Access Compliance Report

Public Rights-of-Way

(Curb Ramps)

Intersection ID: 45764	Main Street: CHRISTENBURY_RD	Cross Street: GREENOCK_RIDGE_CT	Location: E
ADA ID: 1F875B0B9894	Ramp Type: PerpDiag	Initial Pass/Fail: Fail	Overall Compliance: No
Severity Score: 22.5			
Codes/Mitigation Info/Possible Solution		Field Measurements/Component Compliance

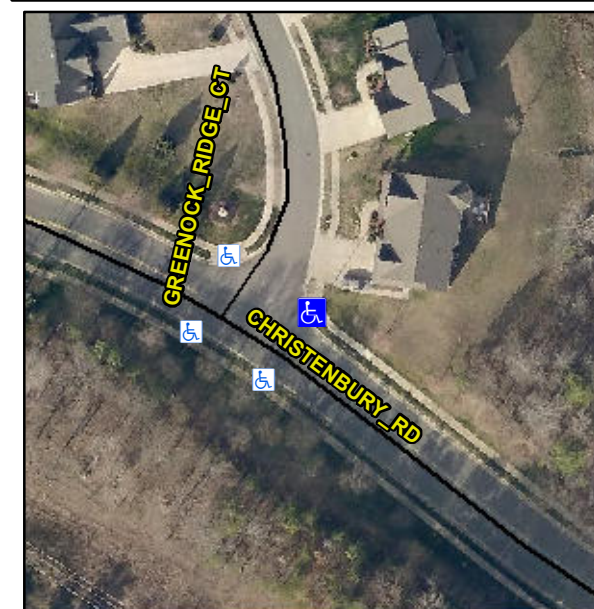
PROW/ADA:

R304.5.1, R304.2.2, R304.5.3

Compliance	Description	Data	Compliance	Description	Data
N/A	Ramp Length (in)	50.0	No	Ramp Slope (%)	10.6
No	Ramp Width (in)	38.0	No	Ramp XSlope (%)	3.5
N/A	Flare Type LT	N/A	N/A	Flare Type RT	N/A
N/A	Flare Slope LT (%)	N/A	N/A	Flare Slope RT (%)	N/A
N/A	Flare Traversable LT?	N/A	N/A	Flare Traversable RT?	N/A
N/A	Landing Length (in)	N/A	N/A	DWS Provided?	N/A
N/A	Landing Width (in)	N/A	N/A	DWS Contrast?	N/A
N/A	Landing Slope (%)	N/A	N/A	DWS Length (in)	N/A
N/A	Landing X Slope (%)	N/A	N/A	DWS Full Width?	N/A
N/A	Landing Curb? (Y/N)	N/A	N/A	DWS Offset (in)	N/A
N/A	Shared Landing?	N/A			
N/A	Gutter Ponding?	N/A	N/A	Gutter Slope (%)	N/A
N/A	Gutter Lip Ht (in)	N/A	N/A	Gutter X Slope (%)	N/A
N/A	Painted X Walk1?	No	N/A	Painted X Walk2?	No
	X Walk 1 Direction	To NW		X Walk 2 Direction	To SW
N/A	X Walk 1 Width (in)	N/A	N/A	X Walk 2 Width (in)	N/A
	X Walk 1 Slope (%)	8.8		X Walk 2 Slope (%)	3.1
	X Walk 1 X Slope (%)	1.9		X Walk 2 X Slope (%)	5.2

N/A	Ramp inside XWalk1?	N/A	N/A	Ramp inside XWalk2?	N/A
	Road Slope (%)	2.6	N/A	Clear Space?	N/A
	Road X Slope (%)	5.5	N/A	Clear Space to XWalk (in)	N/A
N/A	Any Obstructions?	N/A	N/A	Storm Grate/Utility Hazard?	N/A
	Obstruction Type			Storm Grate/Utility Type	
		N/A			N/A
			Yes	Surface Condition? (G/P)	Good

Remove & Replace Curb Ramp With Two New Directional Ramps or Equivalent.
